LAND EAST OF TYE LANE, WALBERTON

TECHNICAL NOTE

**REPORT REF.
183248-12**

Drawing Title:
PROPOSED ALTERNATIVE ACCESS

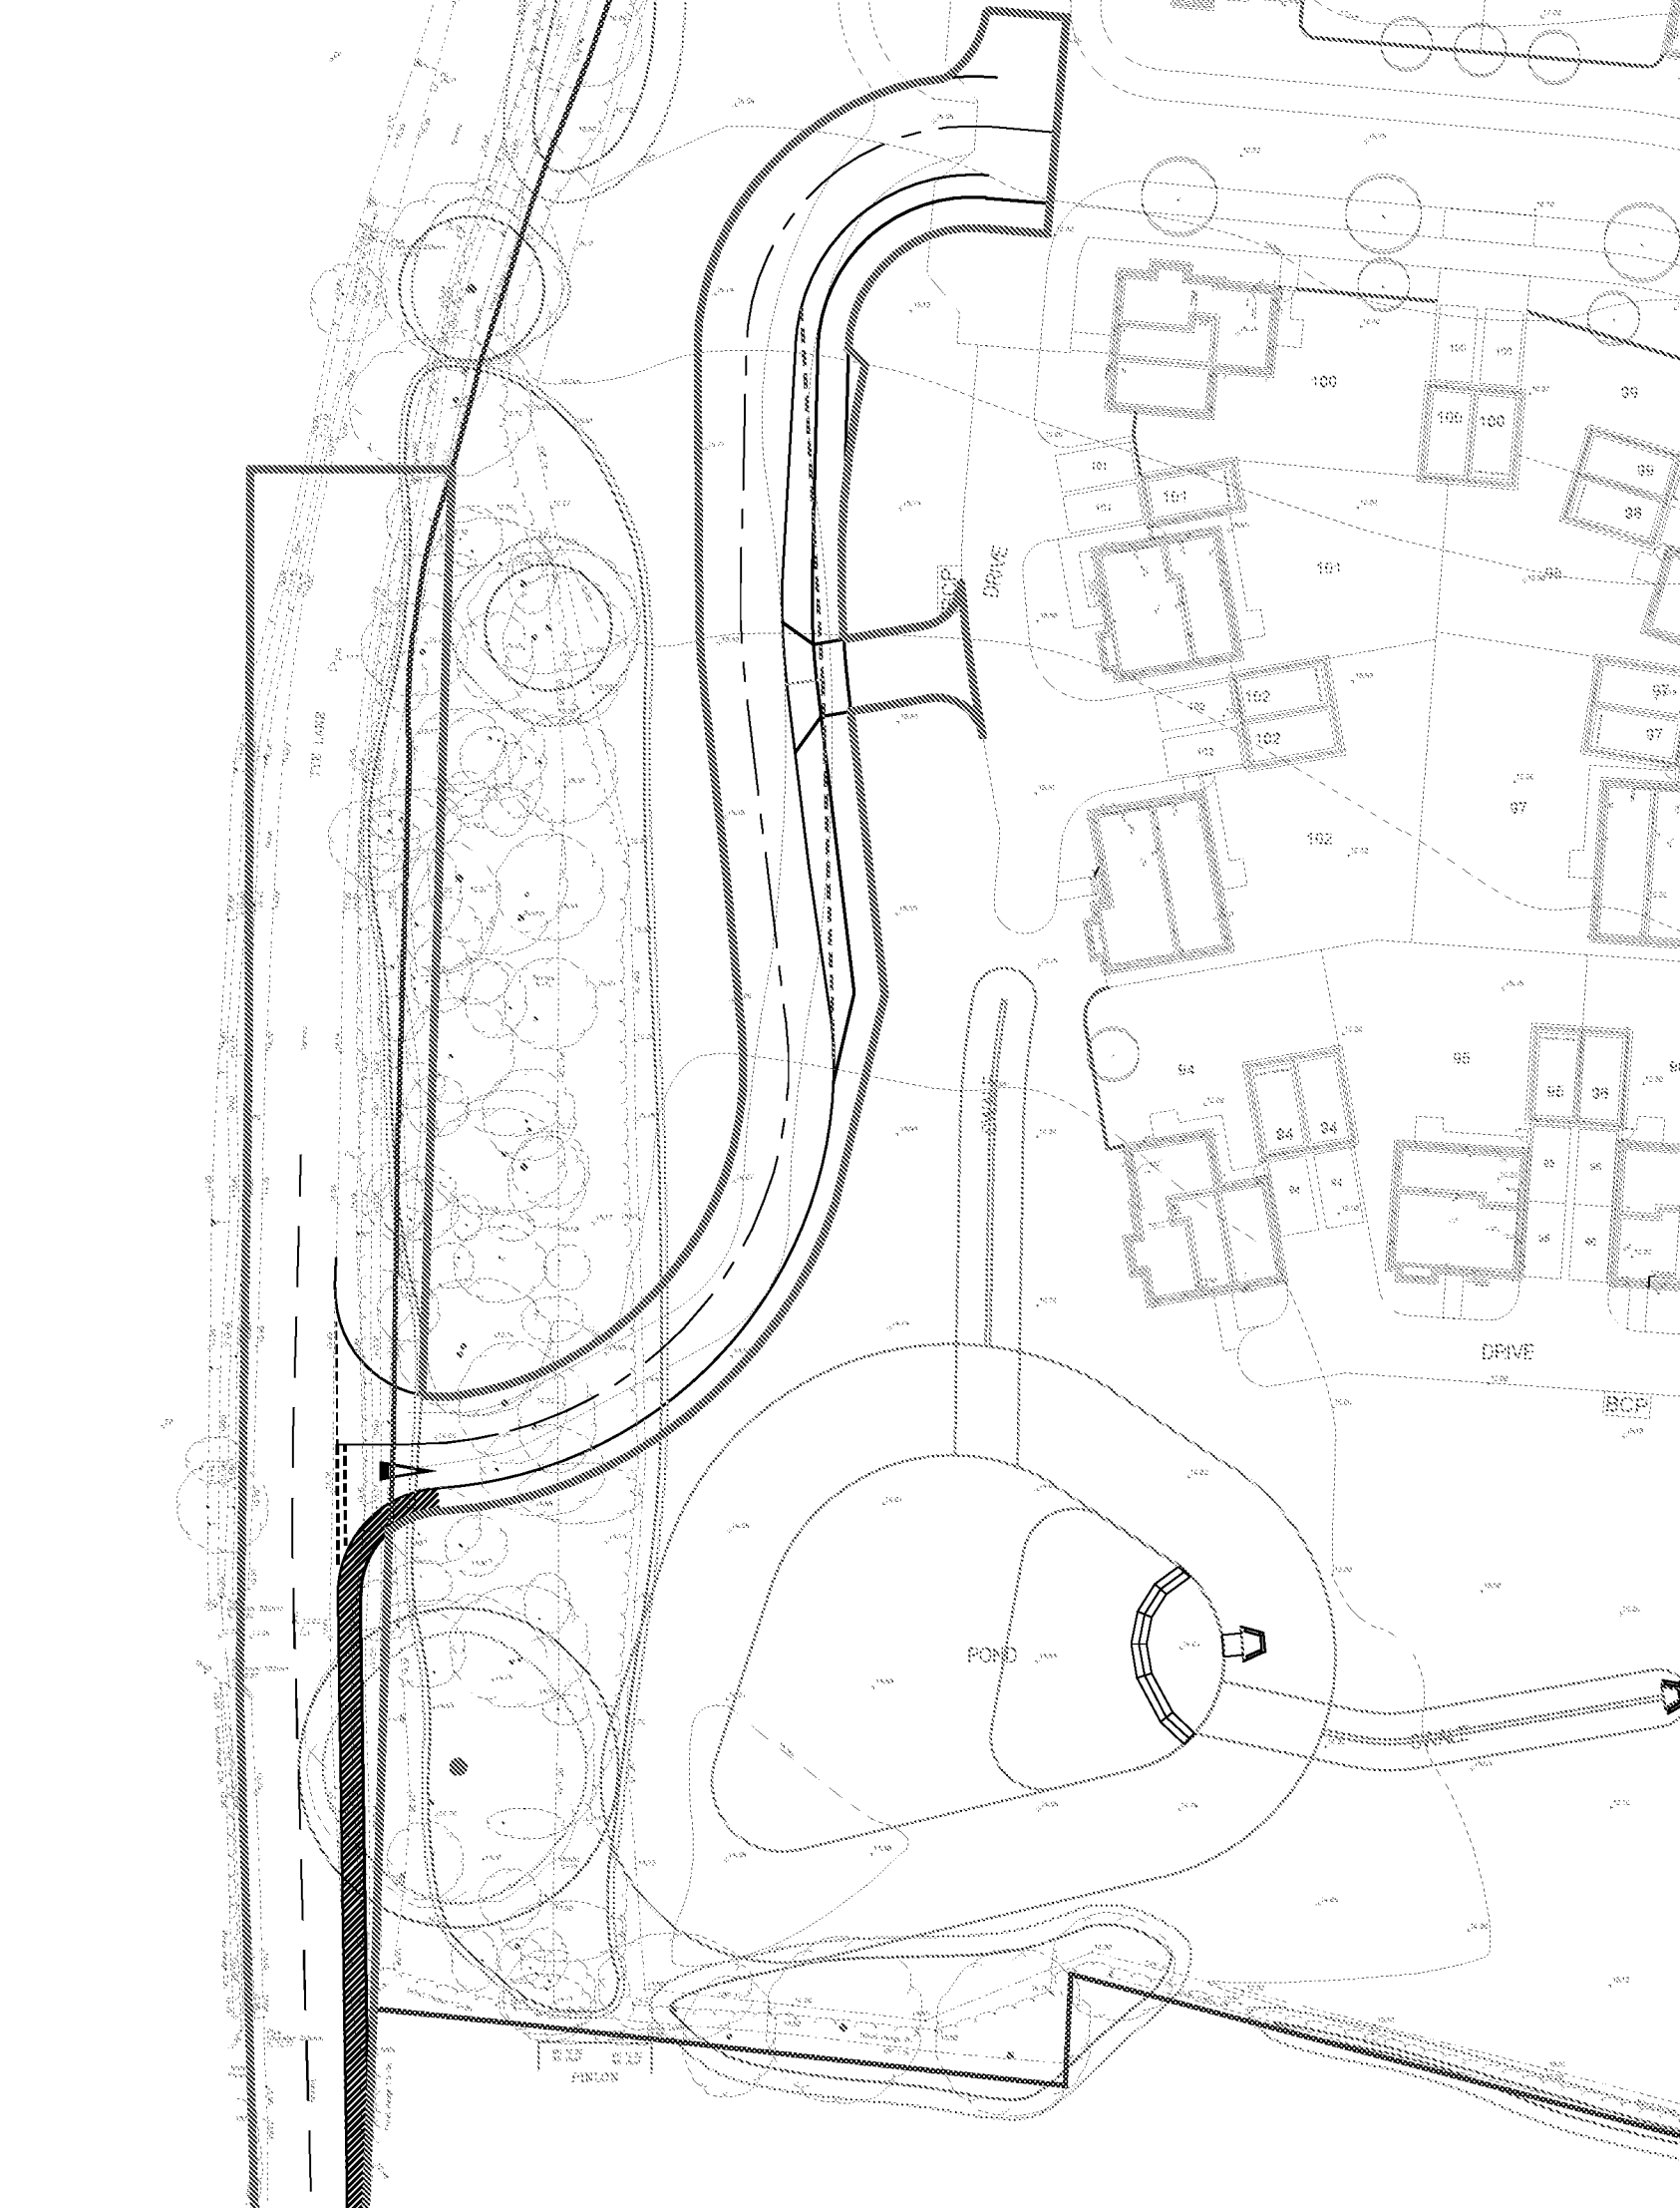
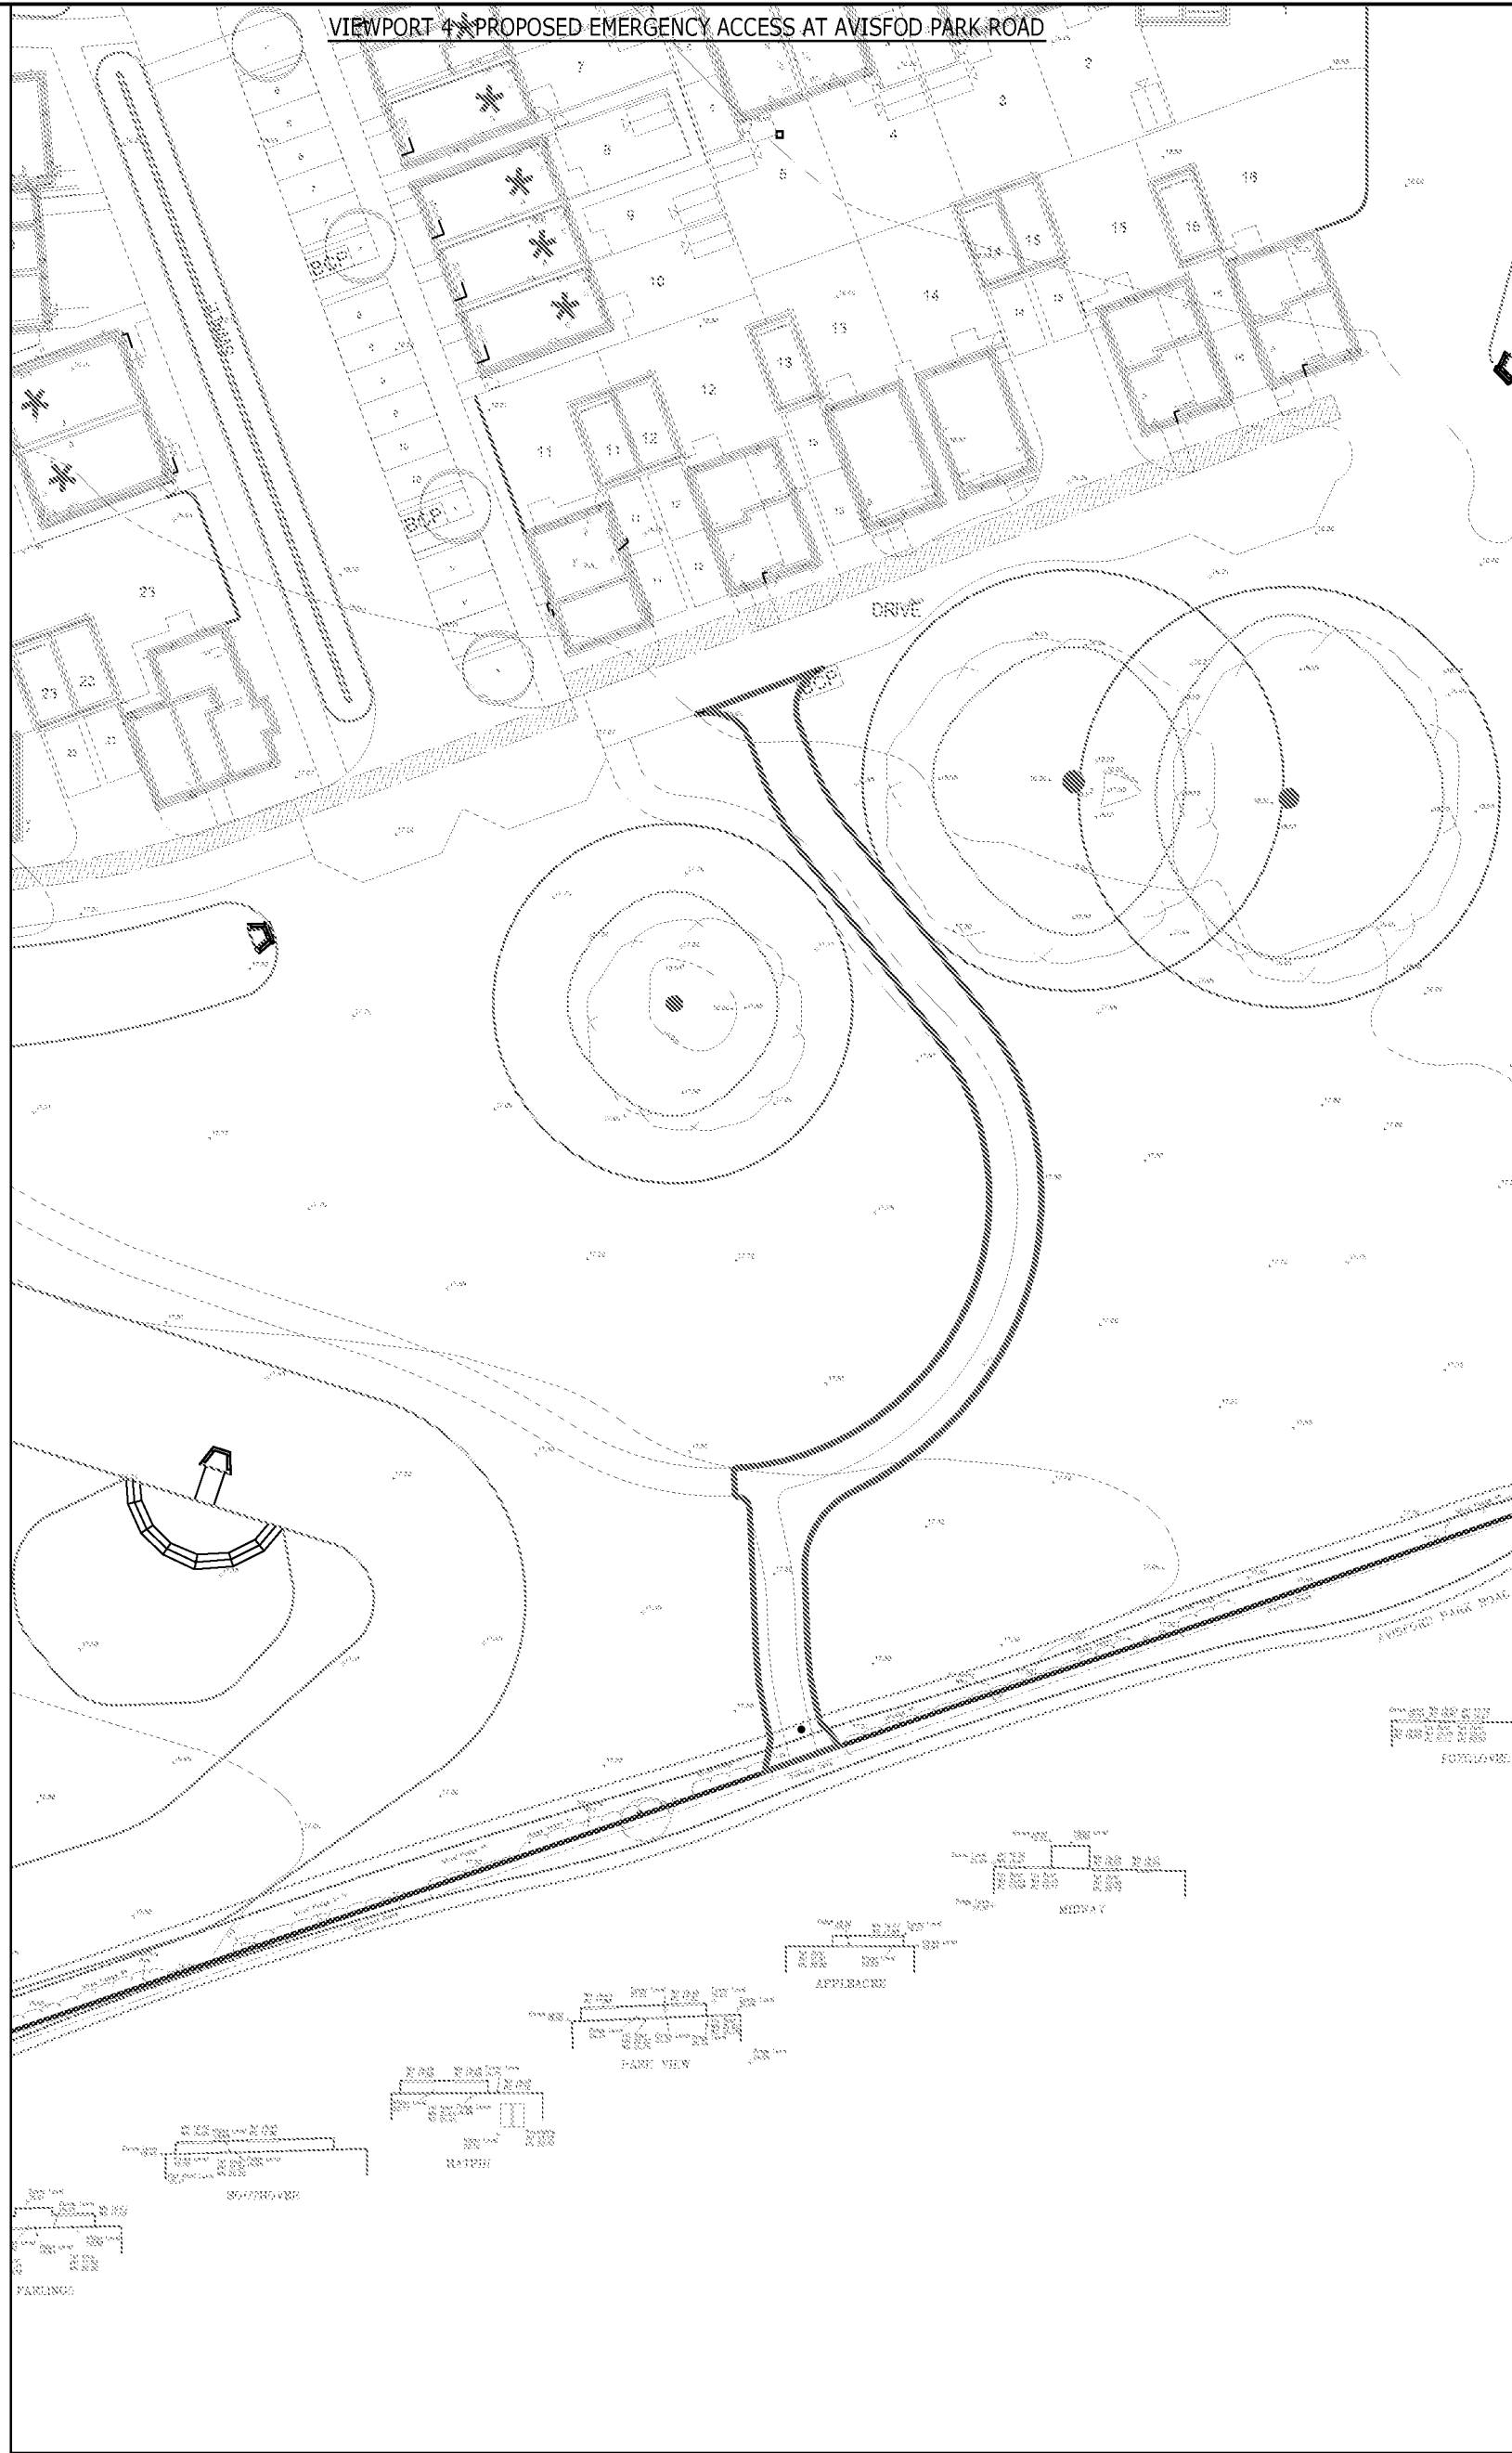
A simple priority junction is to be provided onto Tye Lane as shown on Drawing number 183248-002/003 with a 5.5m wide carriageway and 7m kerb radii. Visibility splays of 2.4m x 54m southbound and 2.4m x 60m northbound are achievable in line with Manual for Streets requirements.

A new 1.5m footway is proposed along the eastern side of Tye Lane where there is currently none. The footway reduces to 1.2m for approximately 25m. Given the anticipated vehicle flows, alternative pedestrian accesses to the site and land constraints the width proposed is acceptable.

In order to accommodate the footway the carriageway width is to be narrowed to between 5.6m and 5.0m. A 5m (over 4.8m) road width would allow a HGV and car to pass.

Inadequate footway width may lead to accidents	It is recommended that the width of the footway is increased to a minimum of 1.5m throughout its length.	We do not agree with the Auditor comments. Inclusive Mobility (DfT, 2005) allows a minimum footway width of 1m in certain areas that suffer from constrained space. Nevertheless, ACE Drawing 183248-002C, incorporates further footway widening to provide a minimum 1.2m width along the narrowest section, also providing a wider footway for a longer stretch of the route too. It should be further noted that there is a further pedestrian access point available to prospective occupiers that links to an existing Public Right of Way. The alternative pedestrian connection is provided by way of a pedestrian/cycle access that can also serve as a point of access in an emergency, and can be seen in Viewport 4 of ACE Drawing 183248-002C. Further, the access point and use of the proposed widened footway would only come into use should the Bypass be implemented and hence the northern end of Tye Lane closed. This would result in a significant reduction in vehicle traffic along Tye Lane and the likelihood that a pedestrian pushing a pram met not only another pedestrian but also a vehicle travelling along Tye Lane all at the same time would be negligible. In light of this the proposed widened footway is considered to safely accommodate the likely pedestrian footfall in the context of anticipated vehicle traffic, and will be supplemented by an alternative pedestrian connection, is suitable to serve the needs of the development.	It is acknowledged that the footway to be provided is below 1.5m for approximately 50m, with approximately 25m being 1.2m. The footway would also only be implemented should the A27 Arundel bypass be constructed and Tye Lane stopped up to the north of the site access which would reduce the number of vehicle trips along Tye Lane. Alternative pedestrian and cycle access to the site within the current planning consent already provides a route onto Avisford Park Road and a link onto the Walberton playing fields enabling access to the primary school.	Footways as proposed on ACE Drawing 183248-002C will be provided should the access design be implemented as a result of the Bypass of the A27.

- 3.8 To provide the new footway, the Tye Lane carriageway has been slightly narrowed to between 5.6m and 5.0m. This is still wide enough for an HGV and car to pass (which requires 4.8m) and is also wider than the existing Tye Lane carriageway further north of the access.

- 3.9 The new footway improvement is 1.5m wide at the access and extends southwards at this width where feasible, reducing to a minimum of 1.2m wide owing to land ownership constraints resulting from the extent of adopted highway.
